**August 21, 2014
BOARD OF COUNTY COMMISSIONERS
ORANGE COUNTY, FLORIDA**

**ADDENDUM NO. 8
IFB NO. Y14-748 PH
ORANGE COUNTY EASTERN WATER RECLAMATION FACILITY
PHASE V AND CENTRIFUGE DEWATERING IMPROVEMENTS**

1 RIB OVERFLOW STRUCTURE
SCALE : NONE

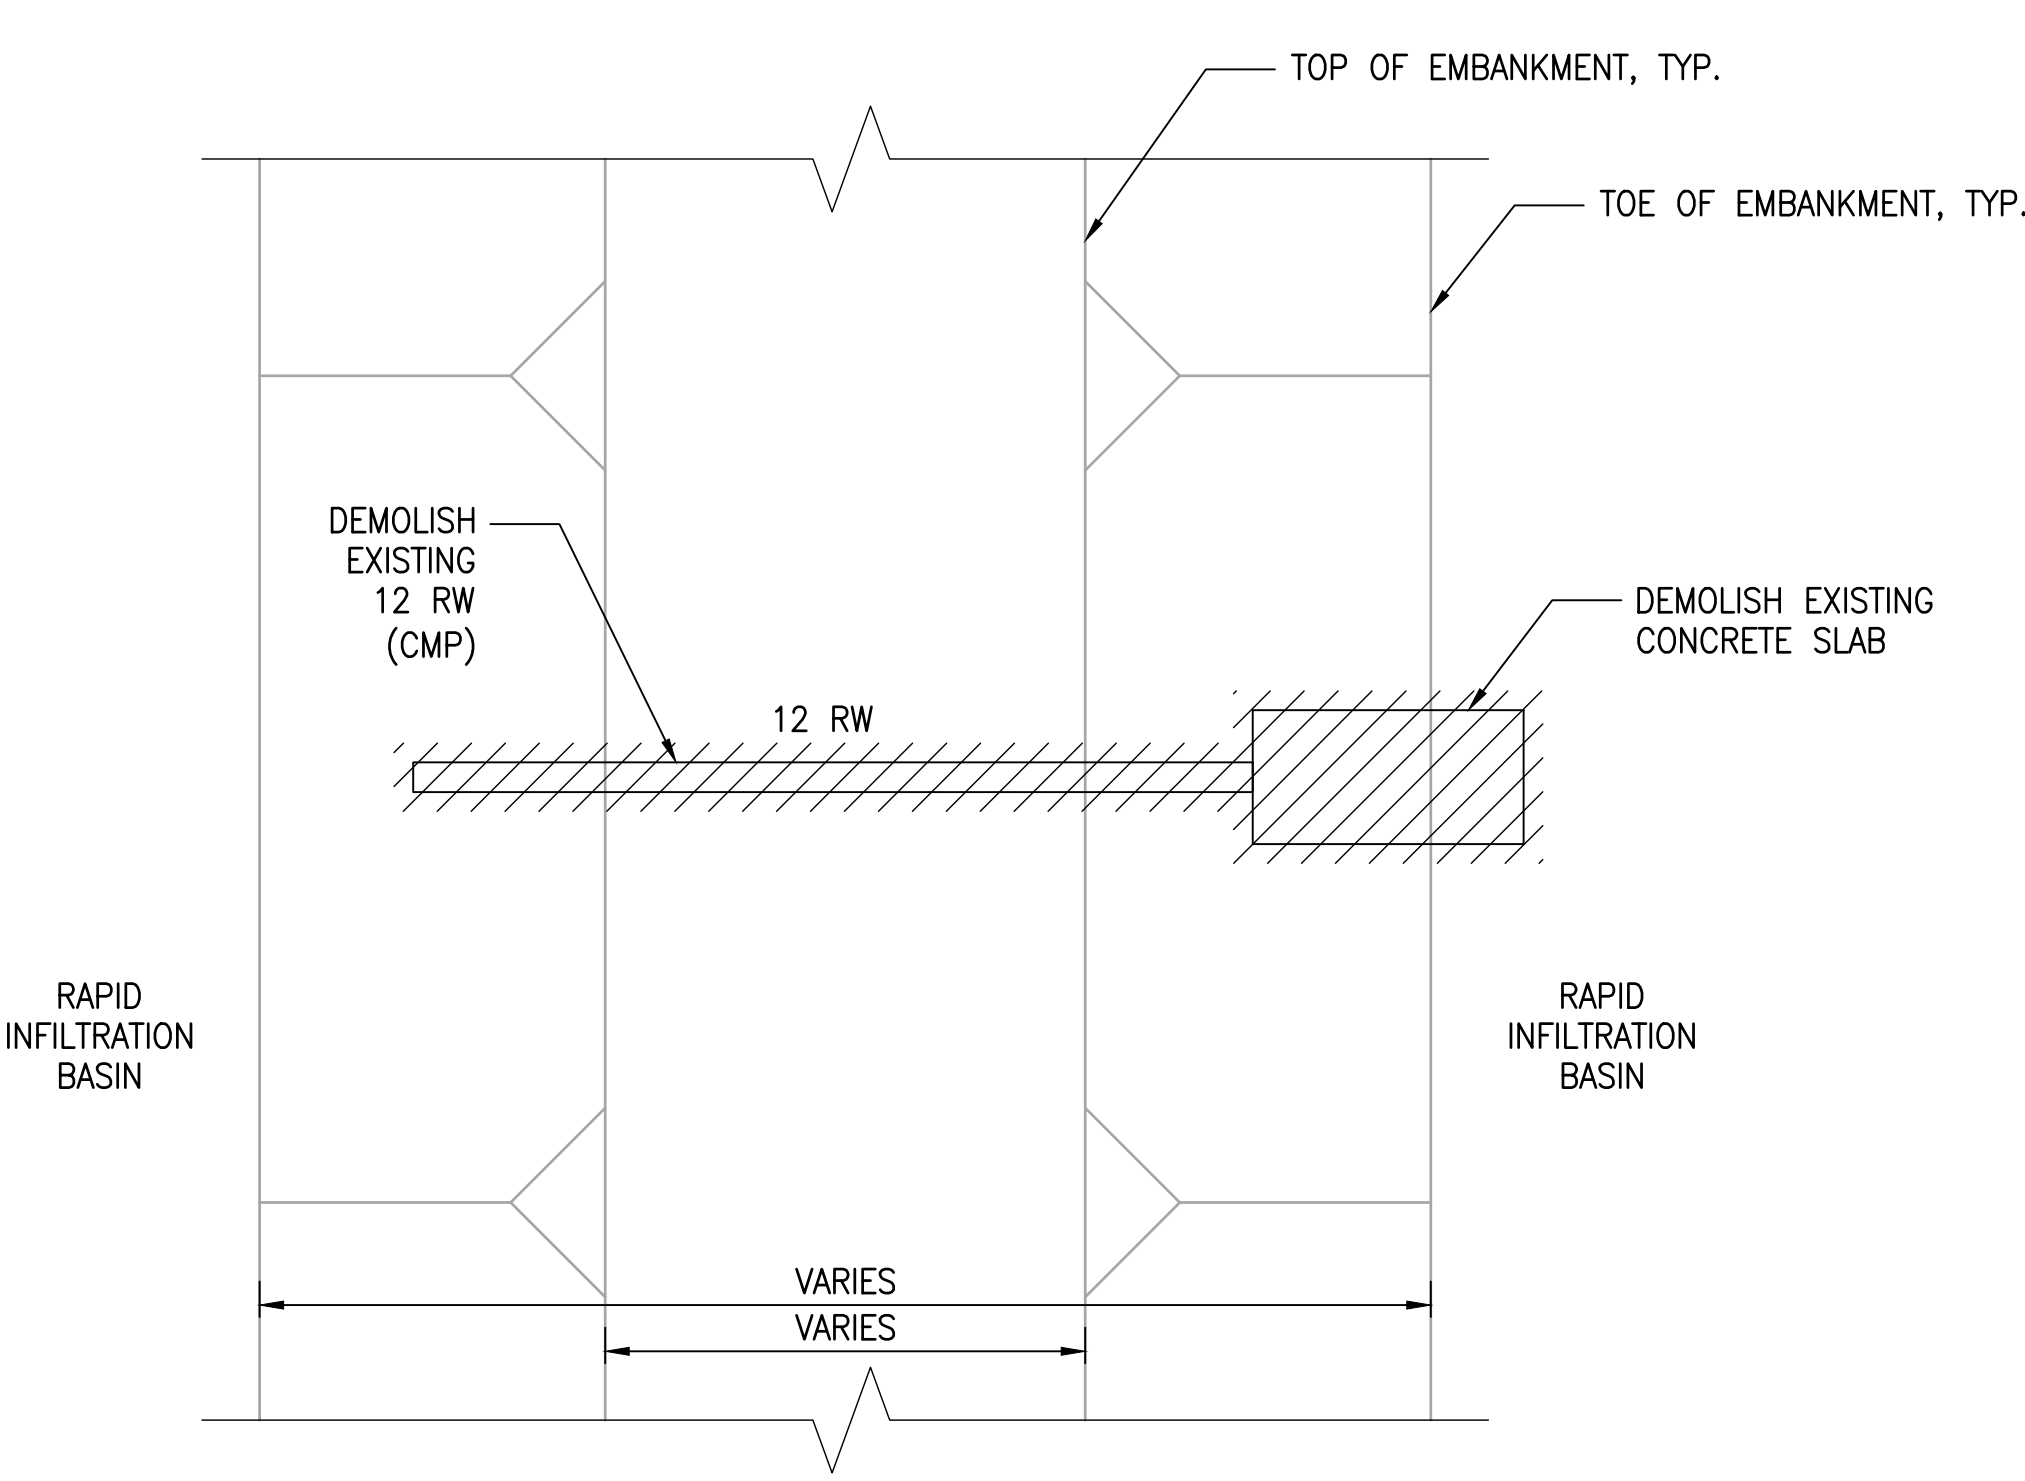
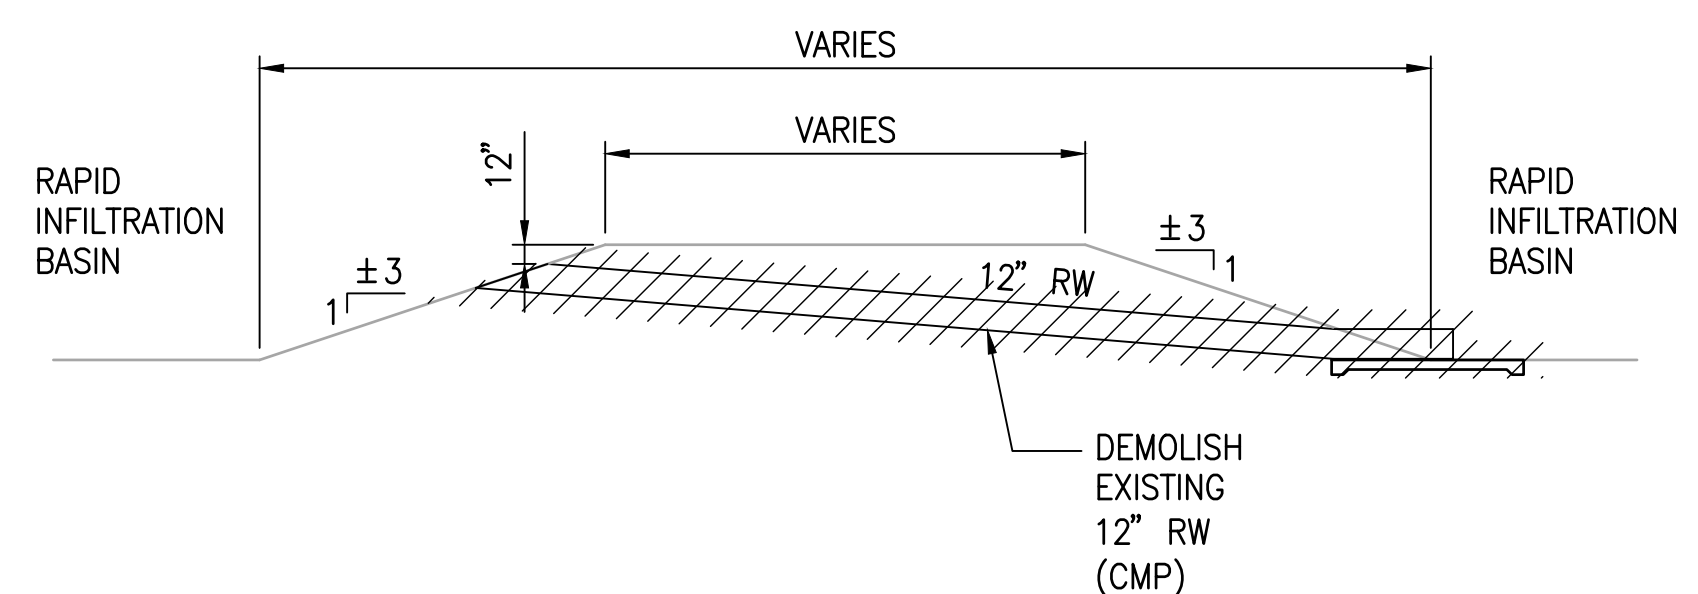
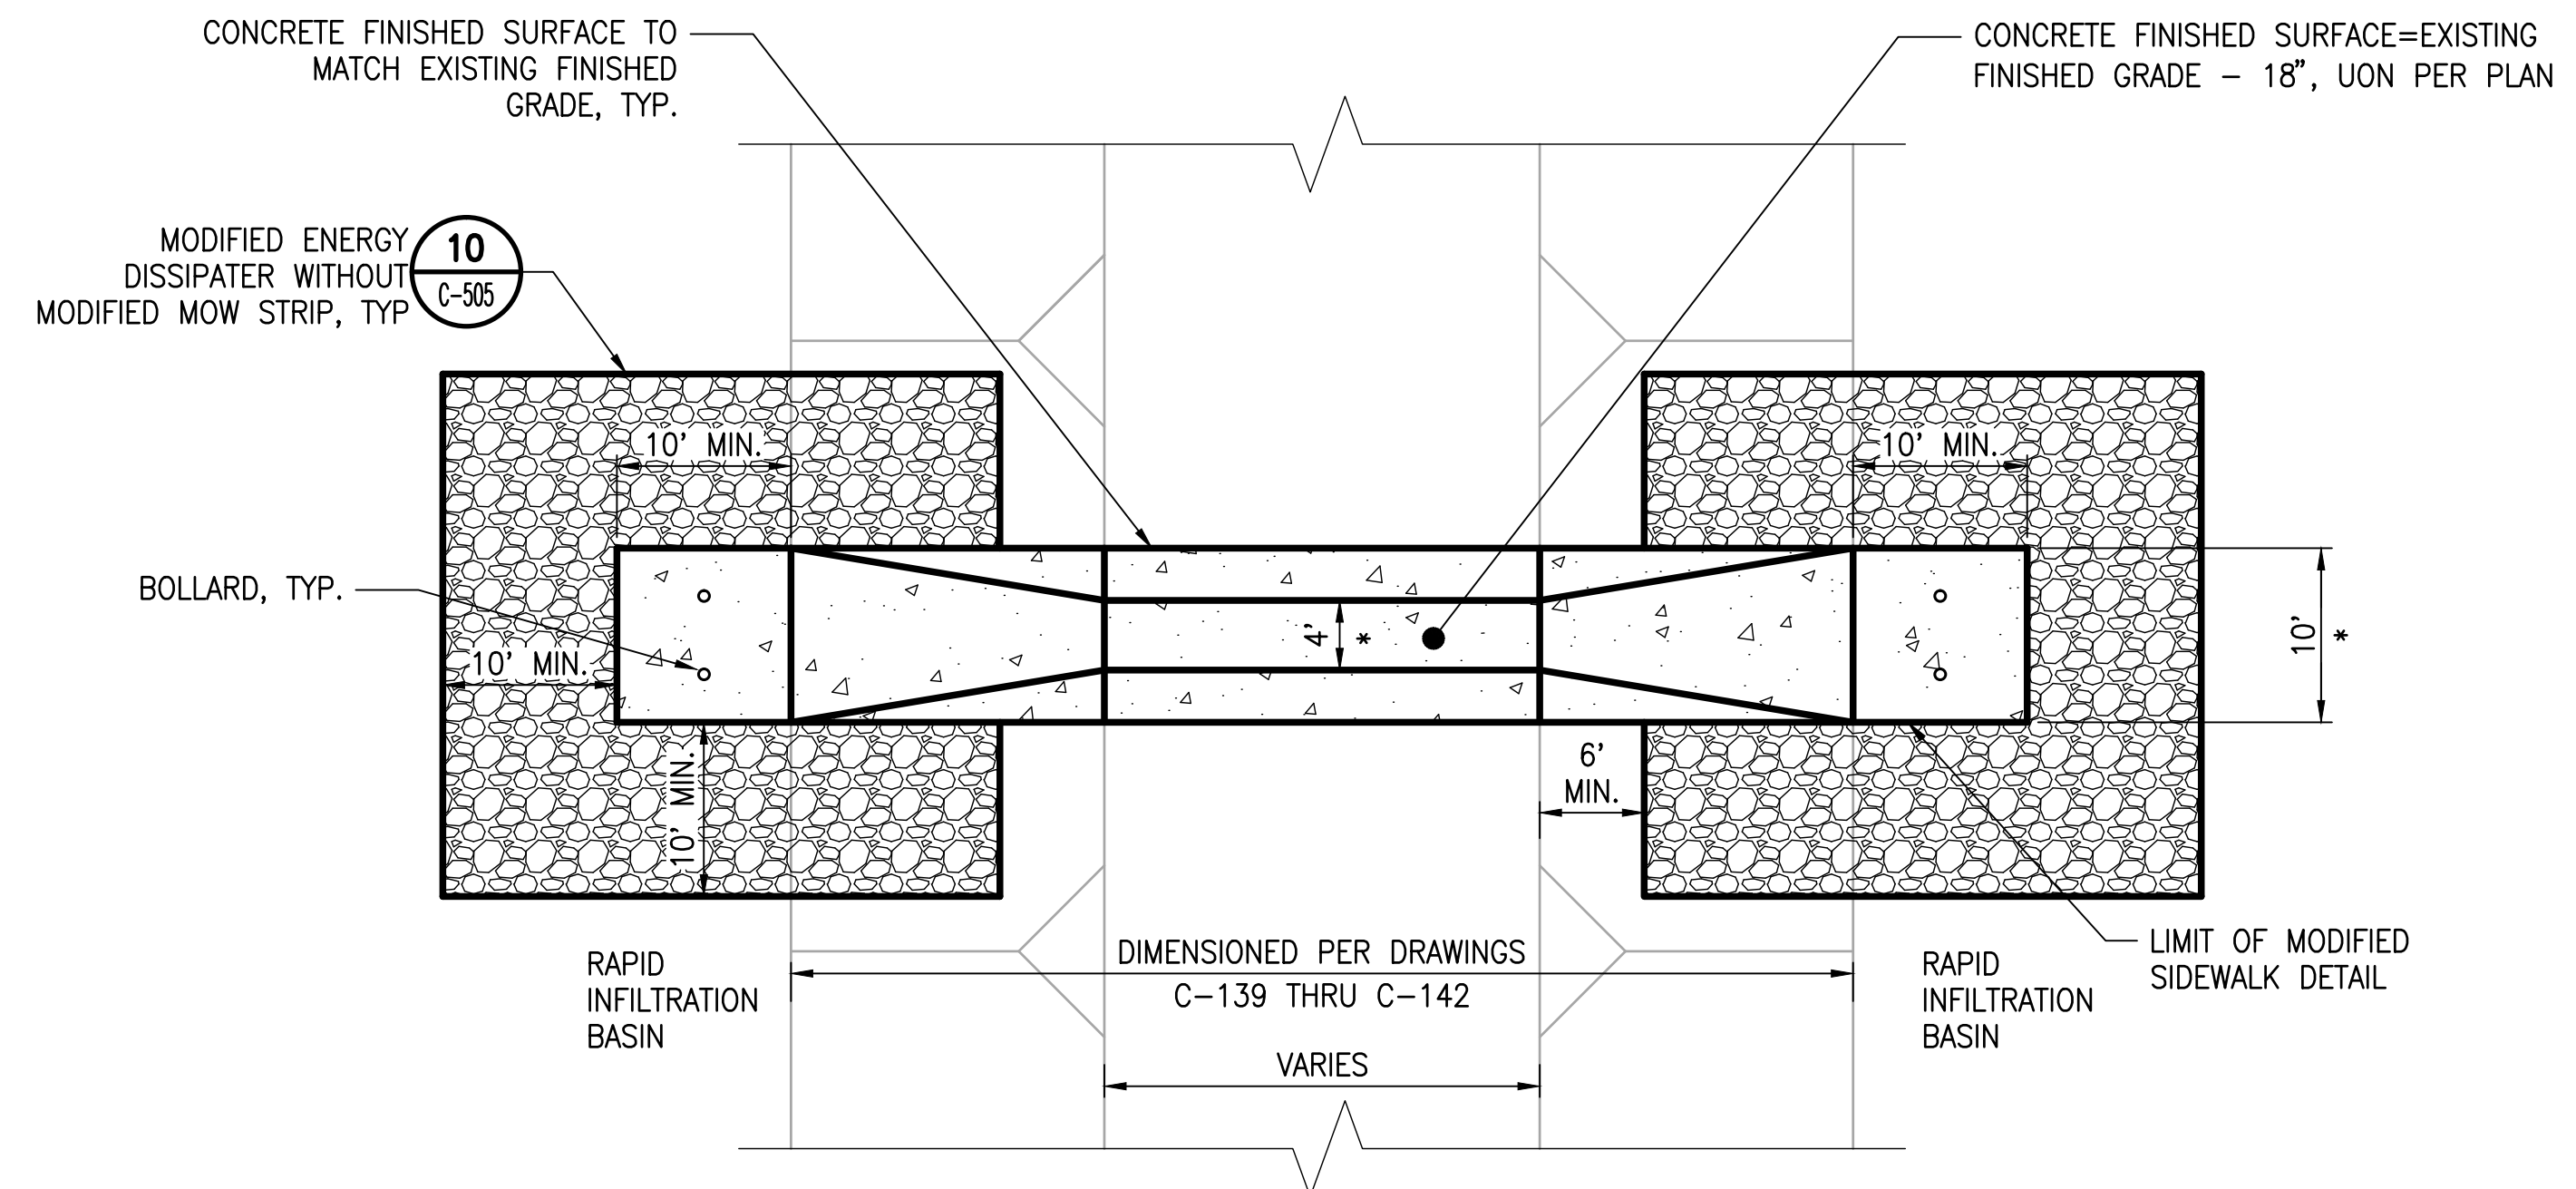
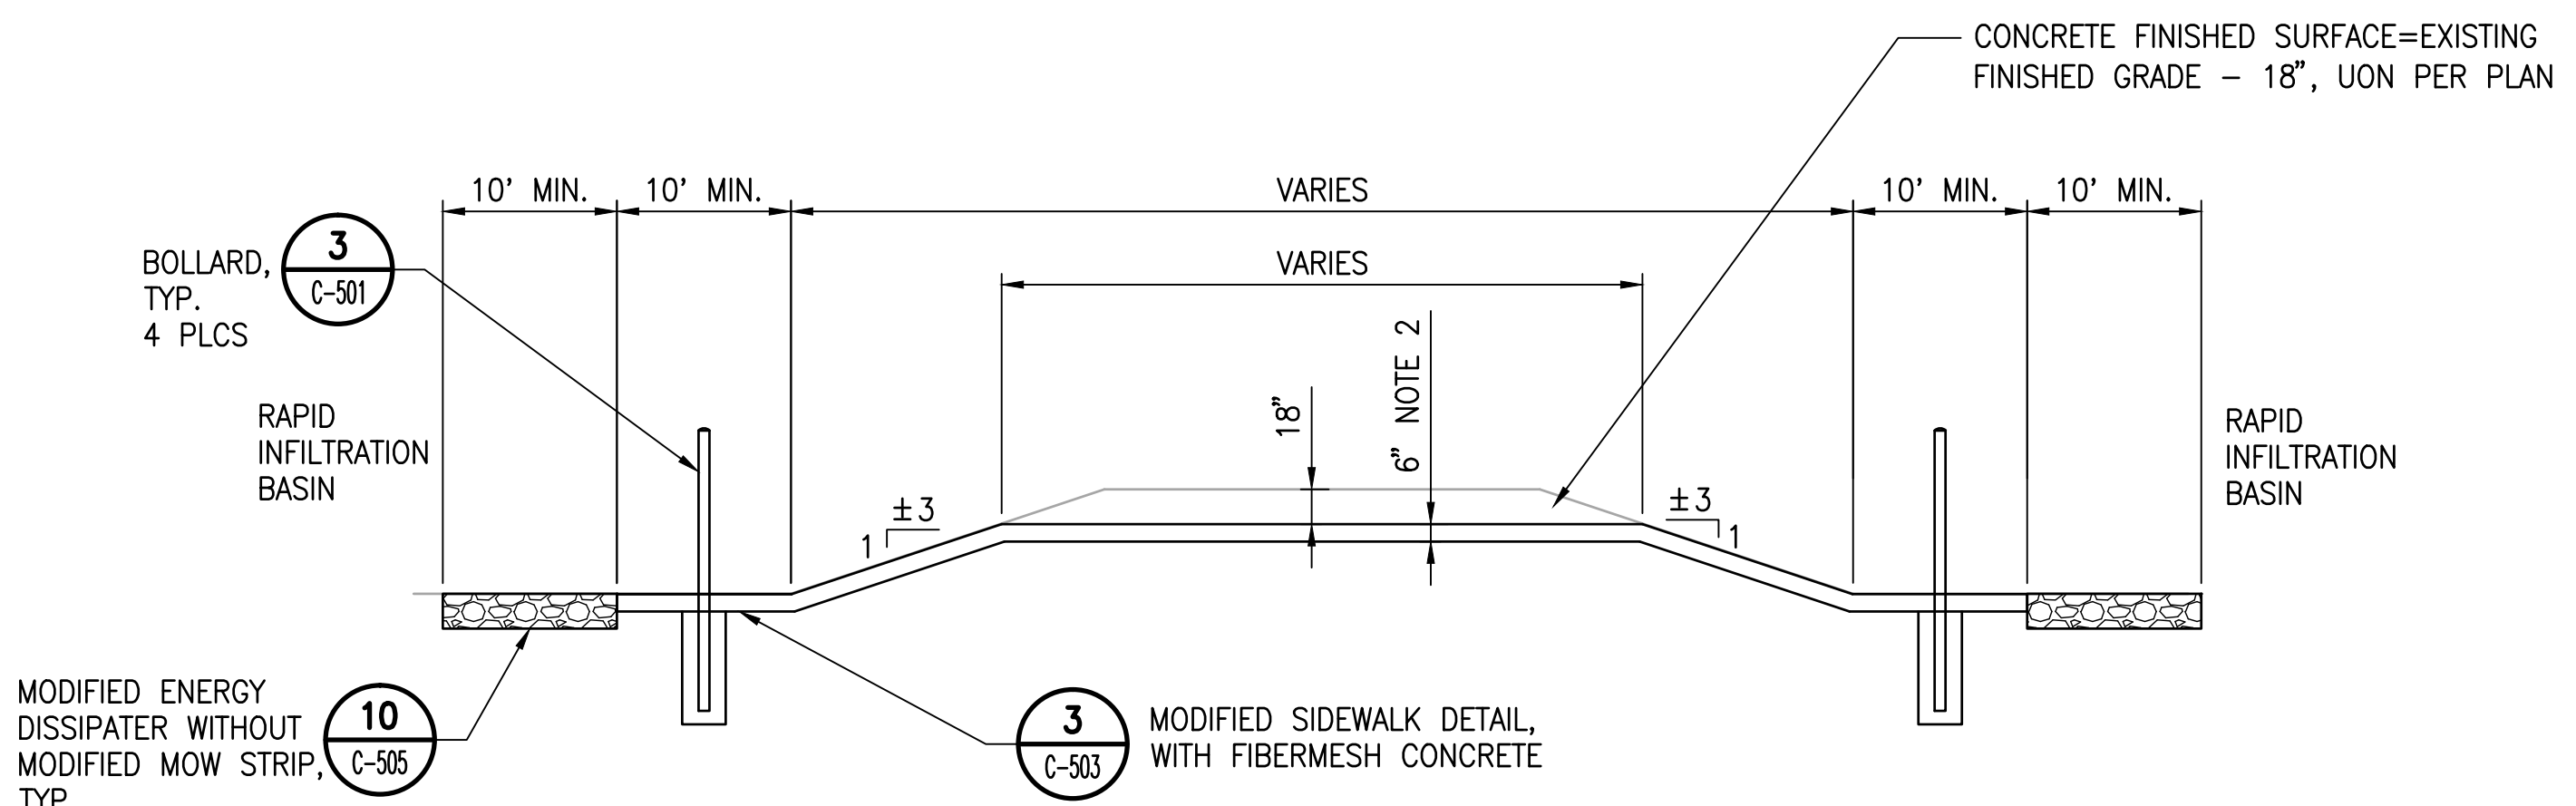
28. Bid Package A: Per detail 1 on C-508 the new overflow structures vary in length. The only way to determine these lengths is to scale the structures via drawings C-139 thru C-142. When scaling these drawings, the width of the overflow structures appears to be 18' whereas the detail on C-508 shows the width to be 10'. Therefore, it leads us to believe that the scaled length is wrong as well. Please provide length and width dimensions for each of the new overflow structures.

Reference Addendum 6, Bidder Question 154 regarding the dimensions of the Modified RIB Overflow Structures within the Reject Storage Pond as illustrated on Drawings C-139 and C-140. Per Detail 1/Drawing C-508, the dimensions of the other RIB Overflow Structures are 10' wide and have a varying length because the slopes of the existing BIBs vary per each respective RIB. Because of this variation, Drawings C-139 through C-142 are revised to include a dimension from the toe of slope to opposing toe of slope for each RIB Overflow Structure. The Improvement Plan on Drawing C-508 is revised to designate the dimension from the toe of slope to opposing toe of slope is "DIMENSIONED PER DRAWINGS C-139 THRU C-142".
